**Town of Kittery
Planning Board Meeting
April 12, 2018**

459 U.S. Route One – Mixed-use development – Site and Subdivision Preliminary Plan Review

**RE: Town of Kittery, Planning Board Services
Site Plan Review Application-The Homestead 459 U.S. Route 1 (Tax Map 60, Lot 24)
CMA #591.115**

OVERALL SITE PLAN
 THE HOMESTEAD
 459 US ROUTE 1 KITTELY, MAINE

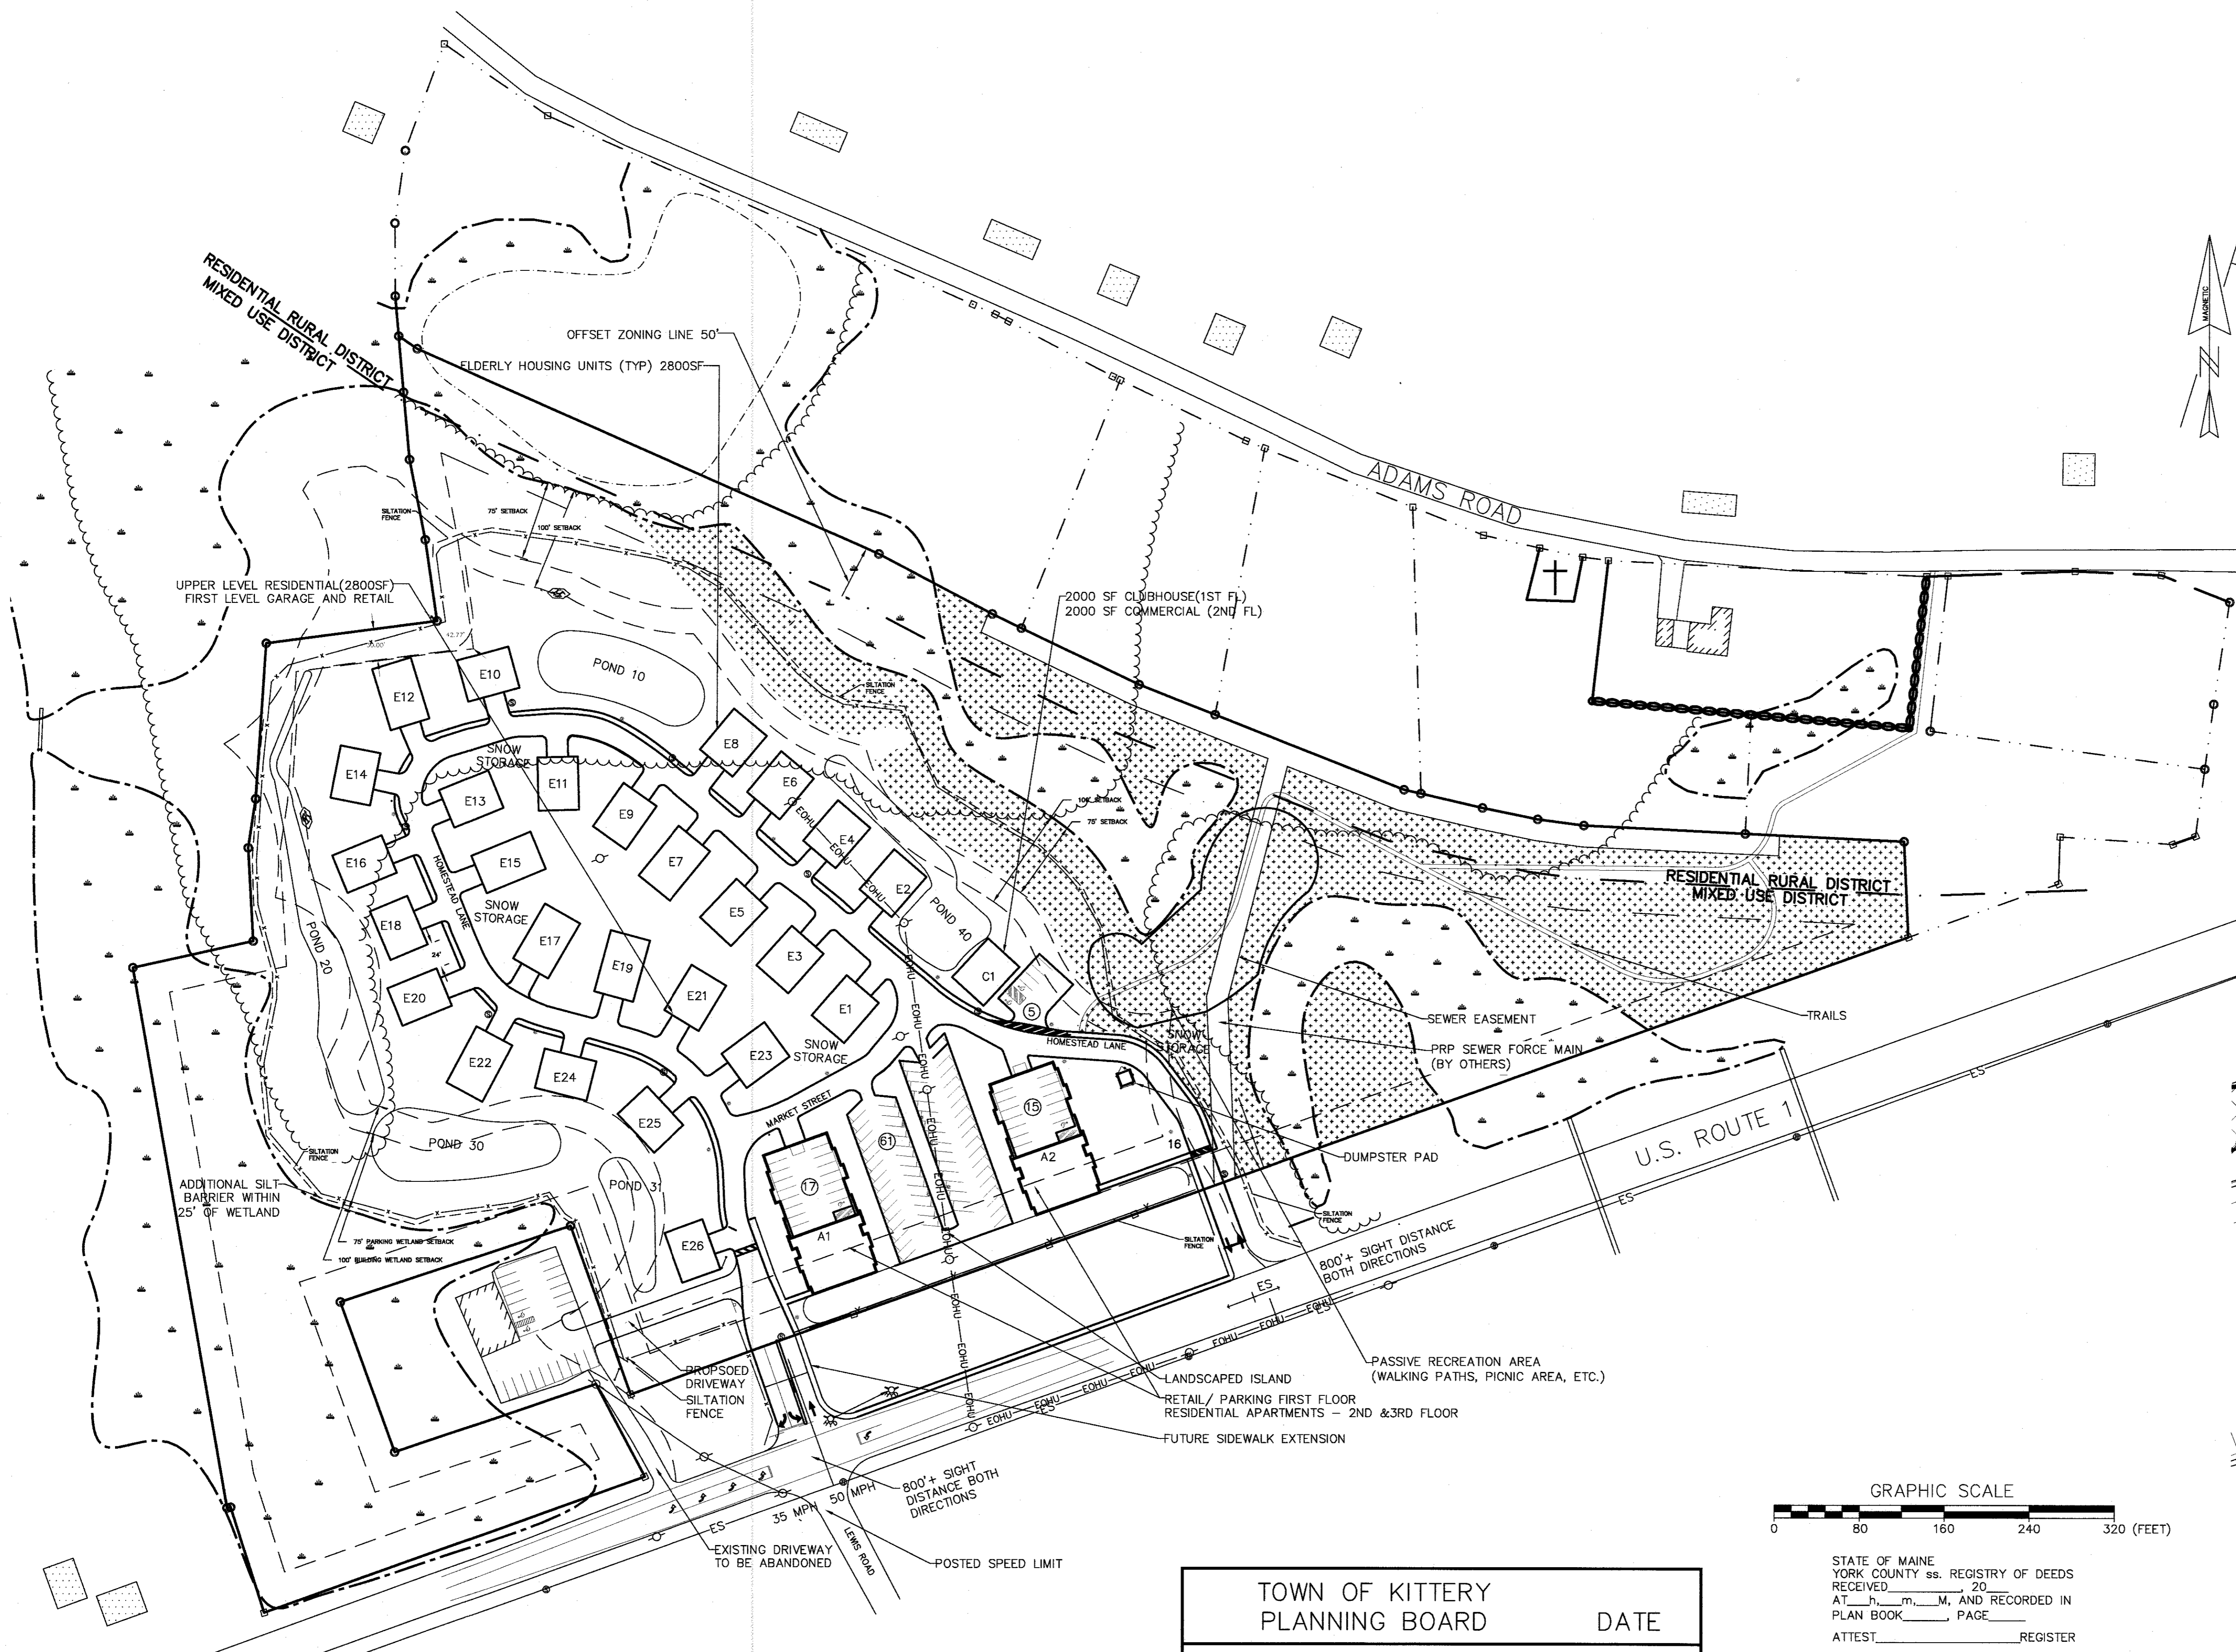
- a. Plan Sheet 1.1's final net residential density statement appears incorrect. Assuming the net residential area is correct after subtracting the wetlands, hydric soils, travel ways, sewer easement and parking, the Net Residential Density statement should read:
$$437,714.7 - (26 \times 10,000) - (16 \times 10,000) = 420,000$$
 as the 26 elderly single-family homes each require 10,000 sf of land area as do each of the 16 apartments.

13. The plan sheets show the Map and Lot as Map 24, Lot 60 when it is Map 60 Lot 24. Also Sheet 1.1 shows a discrepancy in the scale in the title block and the scale on the plan itself.

- D.2. In note 4 on Sheet 1.1, the applicant should list the provided setbacks, frontage and lot size in addition to the required zoning information. However, it appears that the applicant has met all minimum dimensional standards.
- D.7.a.ii. It appears that the applicant has met the required number of streetside trees, but the Board should review if clustering them so tightly together meets the intent of the Ordinance and will permit the trees to grow to maturity.

SITE AND SUBDIVISION PLAN
THE HOMESTEAD
459 US ROUTE 1 KITTEERY, MAINE

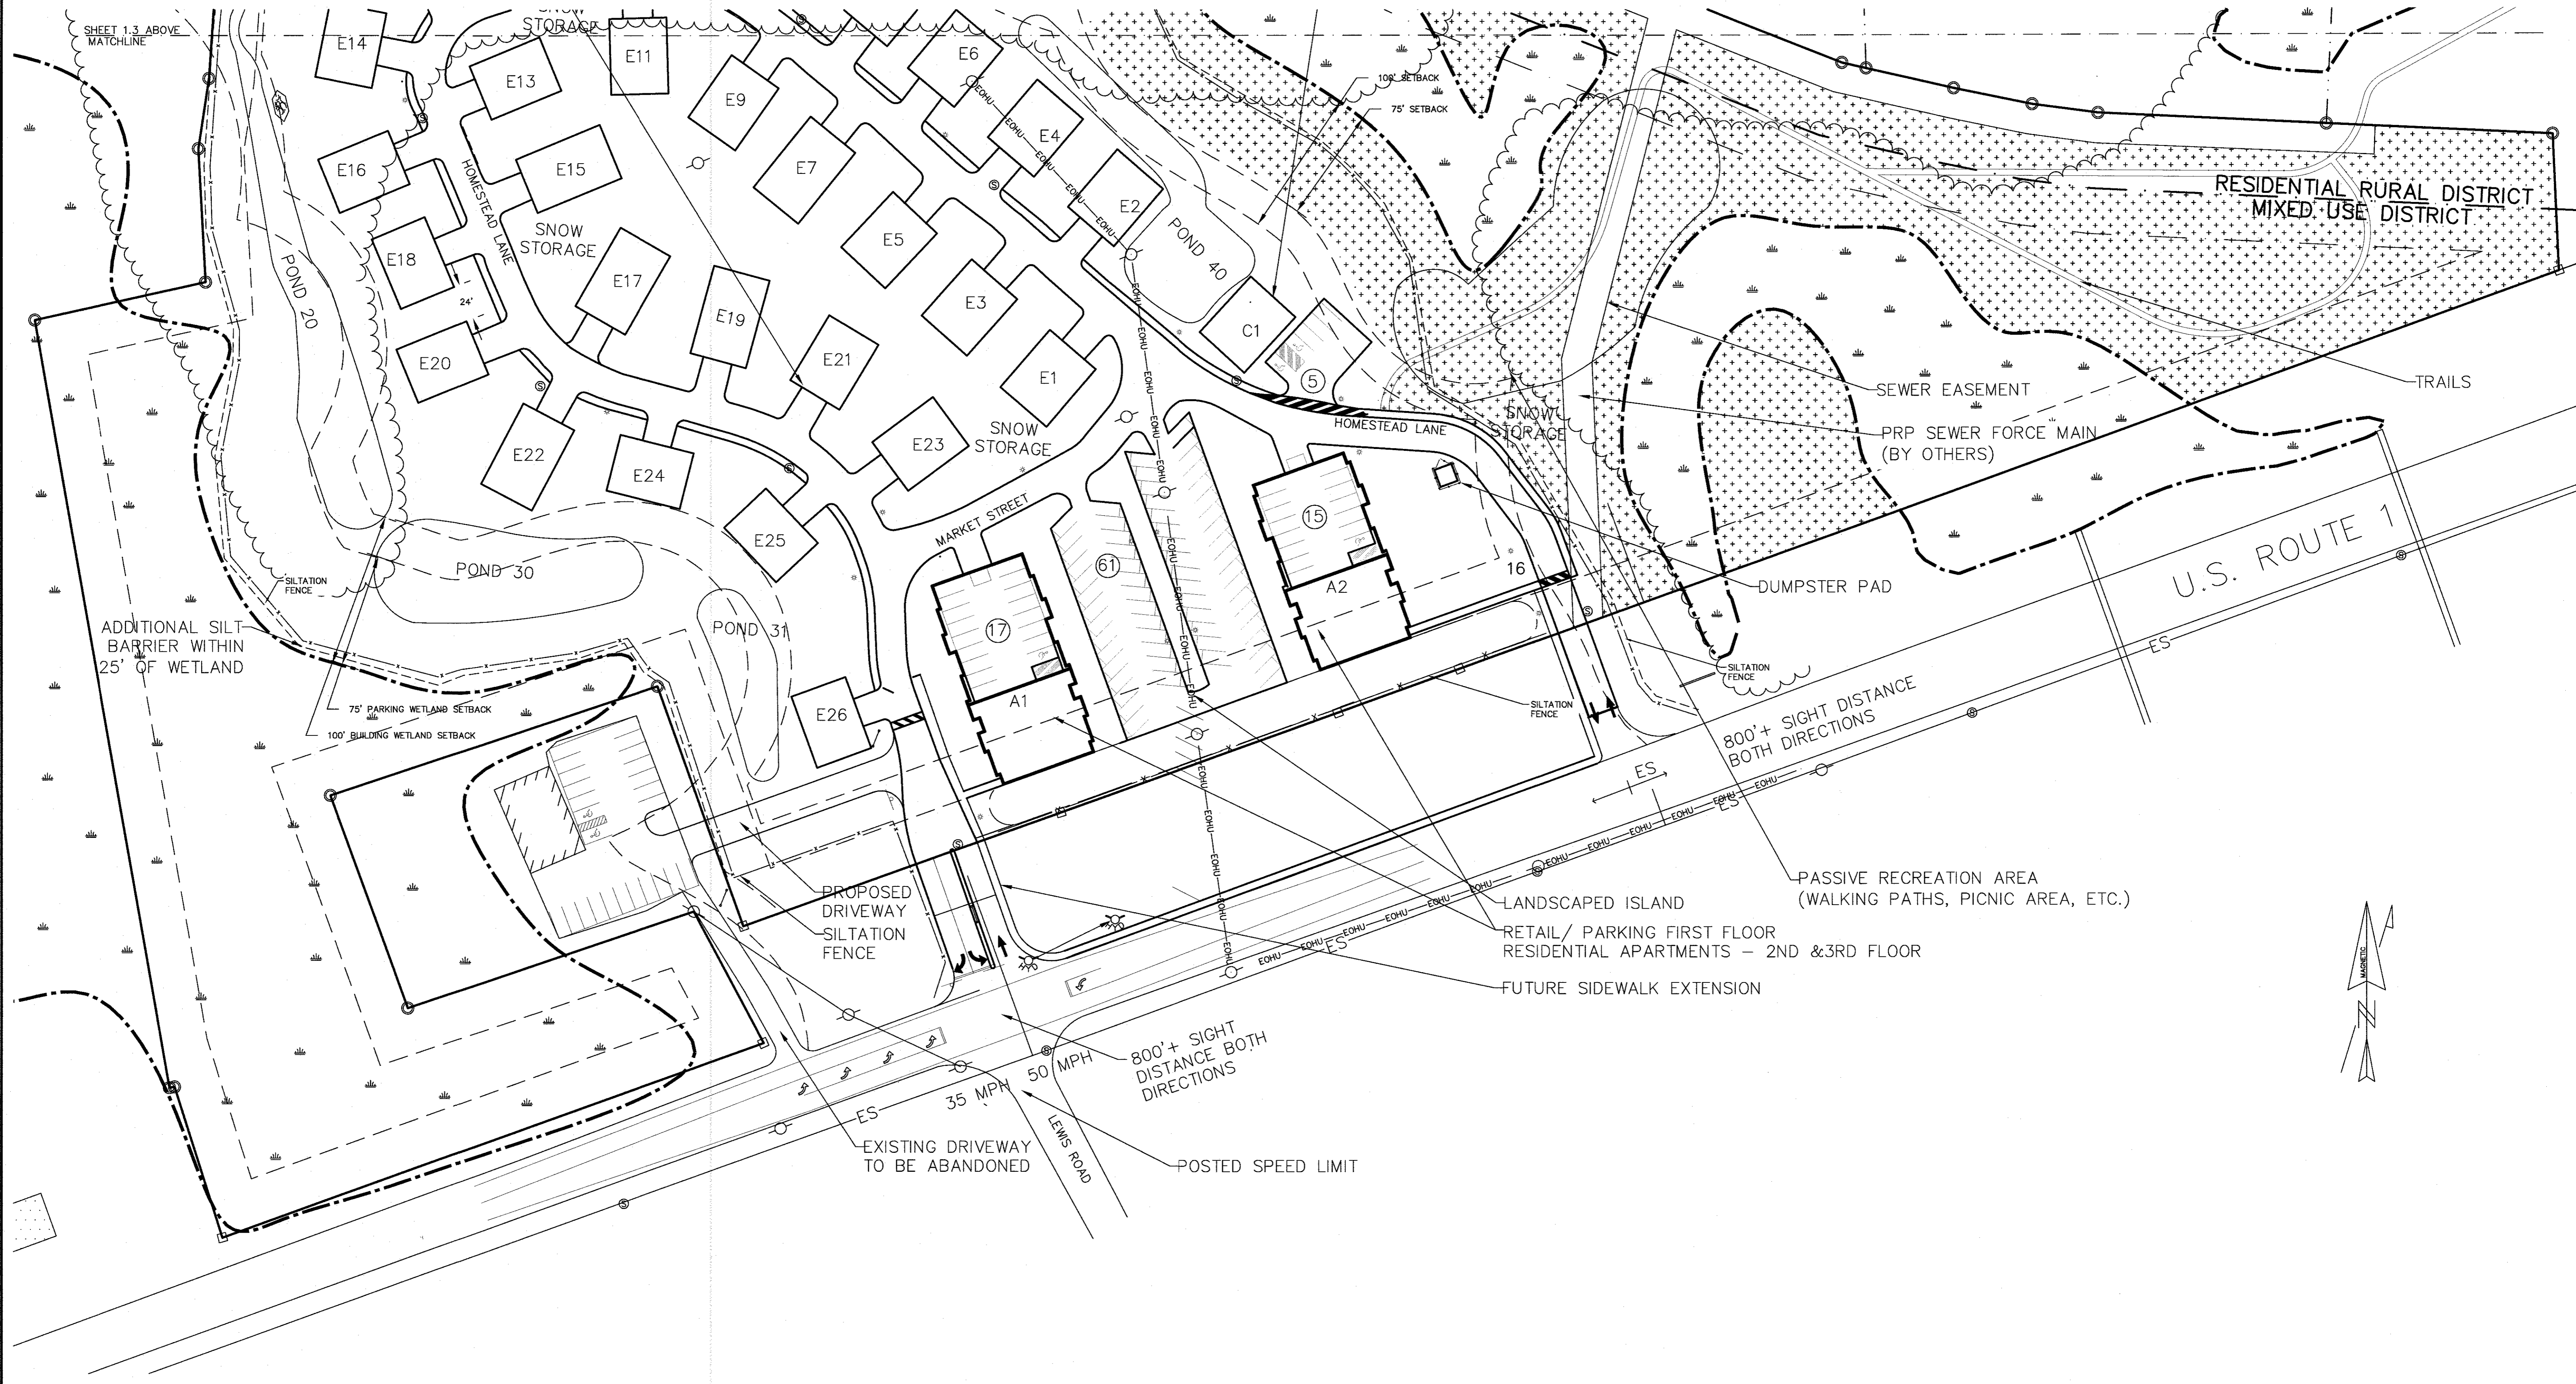
In this preliminary plan submission, the applicant has provided a building with a first-floor club house, while the second floor will be commercial. There are trails shown in the open space and a passive recreation area which includes part of the sewer easement. See Plan Sheet 1.2.
